## Determination 2009/44

### Determination regarding the code-compliance of a commercial building at 46-48 Foreman Road, Hamilton

West elevation

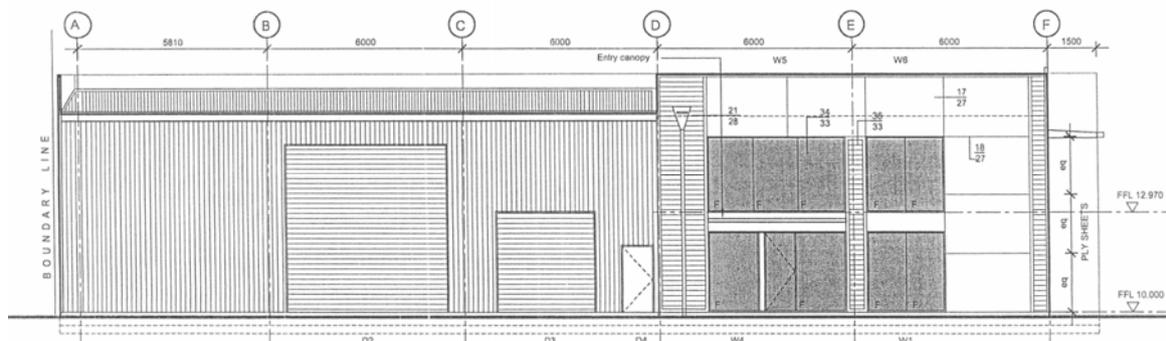
- The external elevations do not clearly show what the claddings are. The south elevation notes a roof overhang as being clad with coloursteel, the roof plans show it as Buytnol. The depth of the Onduline profile is not specified.
- The plans refer to the Butynol membrane to the gutters and the canopies differently as 1.0mm, 1.5mm, and as a 'double layer' application.
- The roof claddings are variously described on the plans as 'LT7', 'MC770' and 'Colorsteel'. The specification refers to the roofing as 'galvanised sheet steel' and '0.55mm thick aluminium'. The structural specification says the roofing is to be '0.4mm Colorsteel Styline'.
- The metal wall cladding is not specified.
- The plans refer to plywood soffits, the specification refers to fibre-cement soffits.
